APPLICATION NO.	FILING DATE	FIRST NAMED INVENTOR	ATTORNEY DOCKET NO.	CONFIRMATION NO.
10/559,611	04/19/2006	Gilbert Ossbahr	82350	1507
26288	7590	10/04/2007	EXAMINER	
ALBIHNS STOCKHOLM AB BOX 5581, LINNEGATAN 2 SE-114 85 STOCKHOLM; SWEDEN STOCKHOLM, SWEDEN			AMIRI, NAHID	
			ART UNIT	PAPER NUMBER
			3679	
			MAIL DATE	DELIVERY MODE
			10/04/2007	PAPER

Office Action Summary	Application No. 10/559,611	Applicant(s) OSSBAHR, GILBERT	
	Examiner Nahid Amiri	Art Unit 3679

DETAILED ACTION

Fig.1

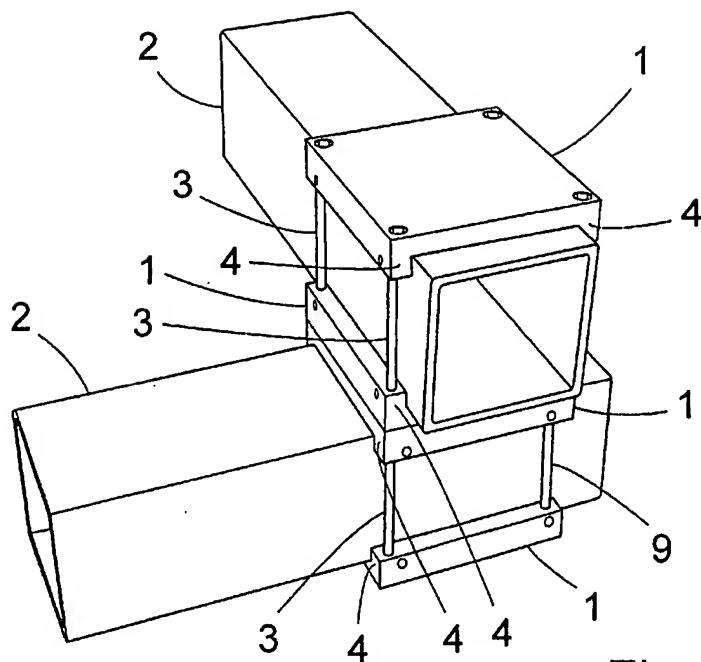
However, the drawings are objected to as failing to comply with 37 CFR 1.84(p)(4) because reference character "3" has been used to designate both "bolts" of Figs. 1-3 and the base of the "fixing plate 1" of Fig. 4. Corrected drawing sheets in compliance with 37 CFR 1.121(d) are required in reply to the Office action to avoid abandonment of the application. Any amended replacement drawing sheet should include all of the figures appearing on the immediate prior version of the sheet, even if only one figure is being amended. Each drawing sheet submitted after the filing date of an application must be labeled in the top margin as either "Replacement Sheet" or "New Sheet" pursuant to 37 CFR 1.121(d). If the changes are not accepted by the examiner, the applicant will be notified and informed of any required corrective action in the next Office action. The objection to the drawings will not be held in abeyance.
